**BEFORE THE PUBLIC UTILITIES COMMISSION
OF THE STATE OF CALIFORNIA**

R.12-03-014
(Filed March 22, 2012)

**COMMENTS OF PACIFIC GAS AND ELECTRIC COMPANY (U 39 E) ON THE
ENERGY DIVISION DRAFT SCENARIOS**

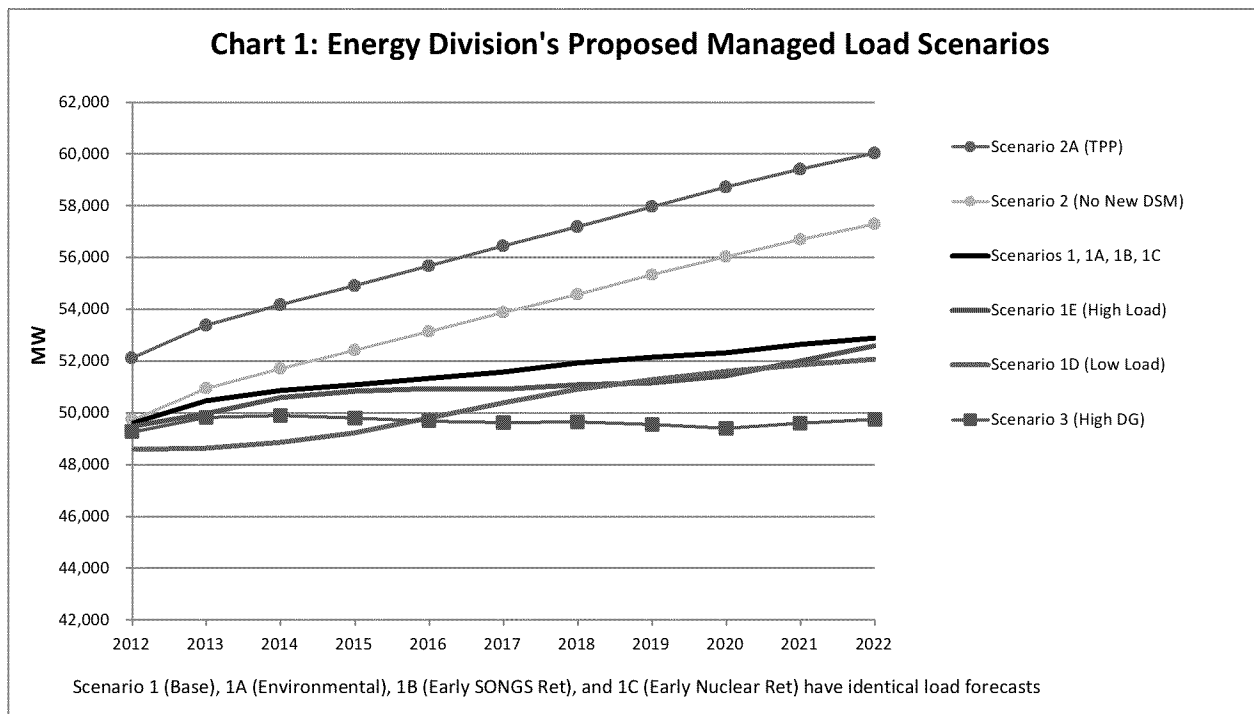
As currently designed, the Energy Division's proposed scenarios and sensitivities do not exhibit this range. In particular, the Base, Environmental, High Load and Low Load scenarios and sensitivities all have managed⁴ load forecasts that are within 800 MW of each other in 2022 (see solid black, red, and blue lines in Chart 1).

Further, the High managed load is lower than the Base case in all years and even lower than the low case for some years. This range of high and low managed load assumptions is too narrow for scenario planning purposes because:

- 1) it does not create a meaningfully broad range of what the future might be;
- 2) the High load is lower than the Base and Low loads; and
- 3) the range between the highest and lowest of the forecasted loads from 2013 through 2020 is actually greater than the range in 2022, implying that the uncertainty in the load forecast diminishes as time goes forward, which is counterintuitive.

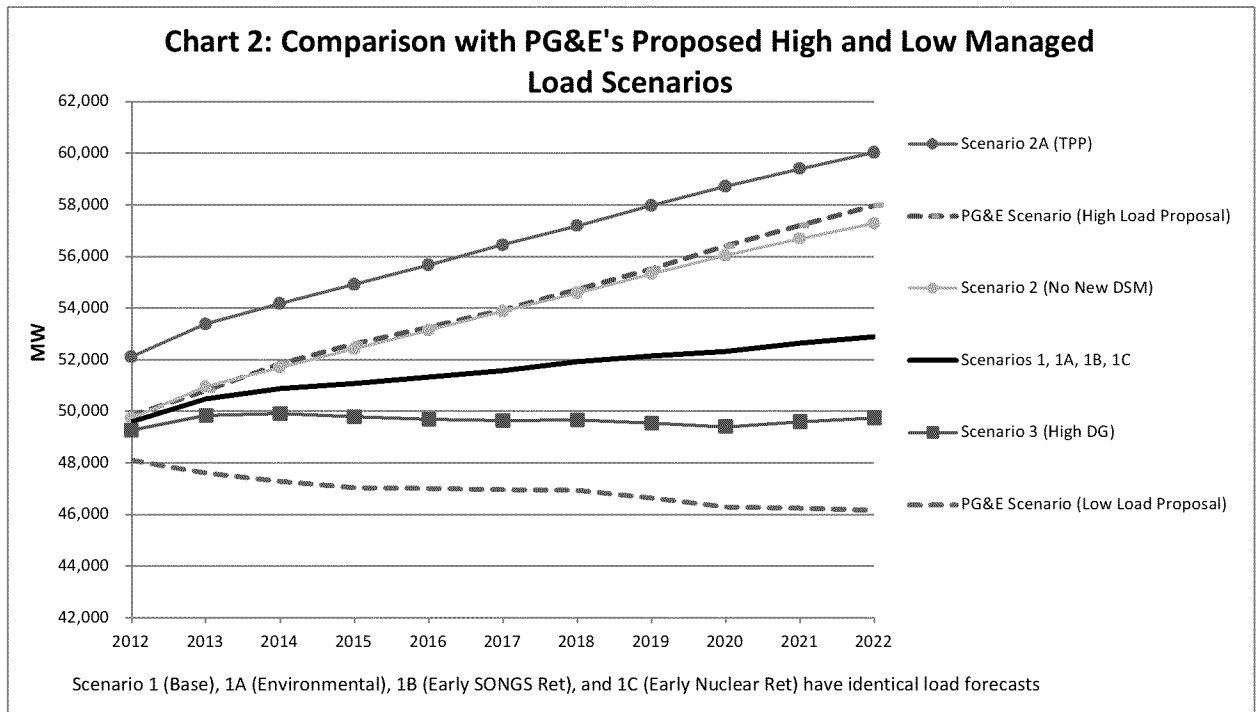
Chart 2 shows how PG&E’s suggested High and Low demand scenarios (dashed red and blue lines) compare to the Energy Division’s other proposed demand scenarios.

While clearly providing a wider range in demand, PG&E’s high demand scenario is extremely close to the Energy Division’s proposed Scenario 2 (No New DSM). On the surface, it may be easy to dismiss PG&E’s high scenario as just the same as the No New DSM scenario and therefore suggest that the No New DSM scenario be a “high” scenario. However, the No New DSM scenario (and its associated TPP sensitivity), because it is constructed using a mid demand forecast with no incremental DSM, does not represent an appropriate way to characterize a “high” scenario.

Chart 2 also shows that PG&E’s suggested Low demand scenario is lower than the Energy Division’s High DG scenario. While PG&E would support a Commission decision to use such a load (since it does provide for a wide range), PG&E shares the Energy Division’s concern that limiting the range of analyses to conform with resource constraints, while meeting

policy objectives for the current LTPP, is critical.⁸ Therefore, PG&E proposes that the High DG scenario reflect a Low demand scenario.

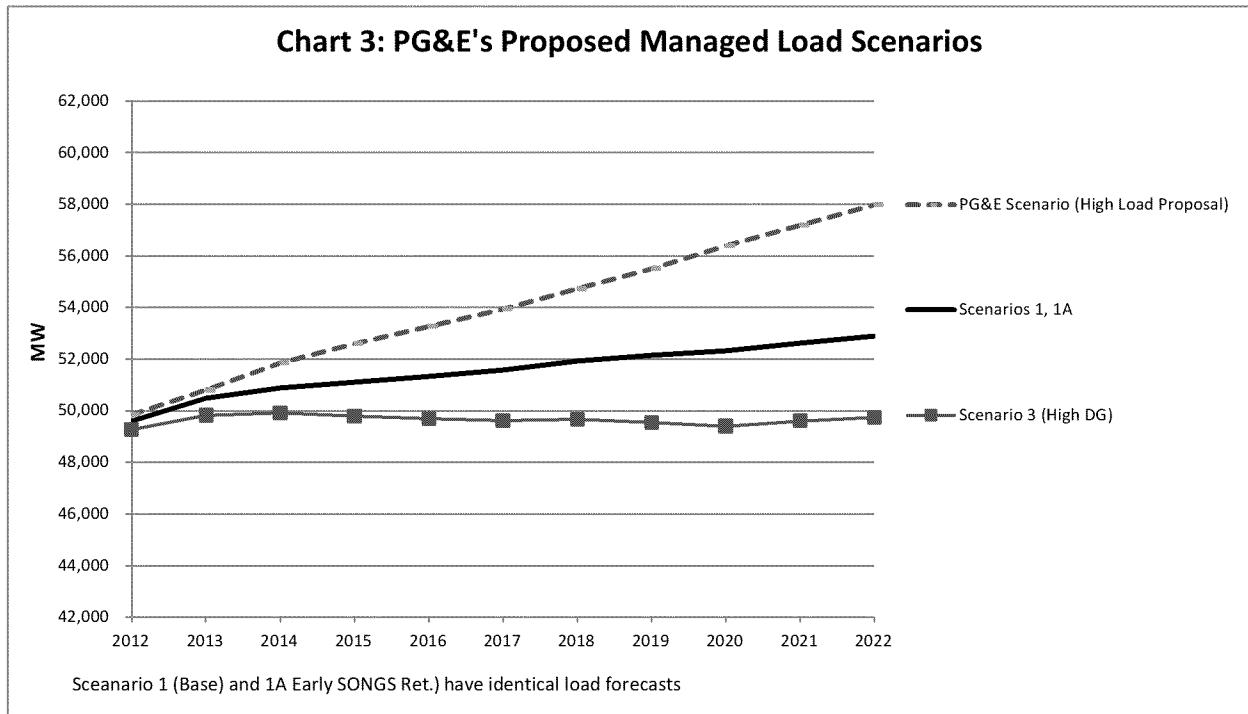
Chart 3 summarizes PG&E overall proposal for the demand scenarios that should be used for this analysis.
